*Proceedings of the Madras Government, Public Works Department,
25th February 1876.*

ABSTRACT.—*Collector's Cutcherry at Cuddalore in South Arcot District.*—Approving the plan of a new —, and forwarding it to the Public Works Department for the issue of further orders.

*Section of the
 Collector's Cutcherry building
 Cuddalore.*

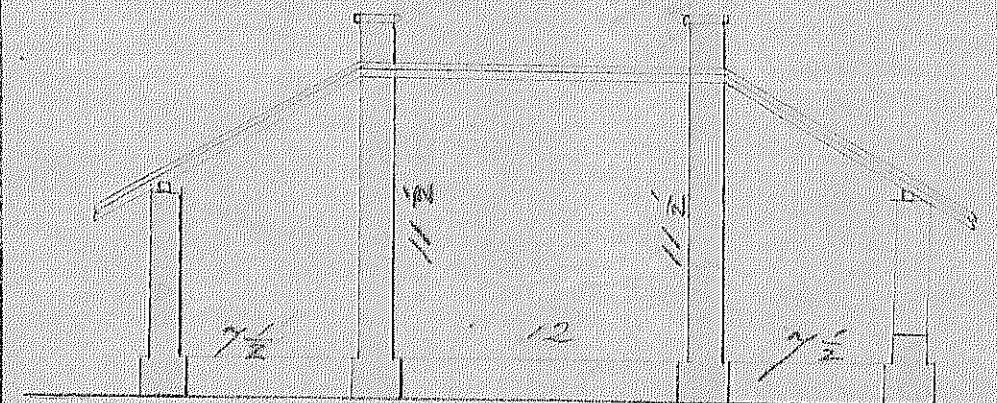
COMMUNICATED to the District Engineer, South Arcot, who will estimate for the alterations to the existing treasury buildings. He will also revise the plan of the new Cutcherry so as to arrange for providing the extra accommodation required by the Collector as conveniently as possible.

5. From the report now submitted, it appears that the existing accommodation for the Treasury is both unsuitable and insufficient, and that by throwing the rooms E and D into one and piercing the wall of the verandah F with arches, as suggested by the Collector, and with the addition of an iron-barred cage, accommodation, which will be both secure and commodious, can be provided for the Treasury.

6. The Board approve of this arrangement and also of the alterations in the plan of the new building suggested in the first two clauses of paragraph 2 of the Collector's letter, dated 4th September 1875, with the view of providing accommodation for the English and Vernacular Departments and their current records.
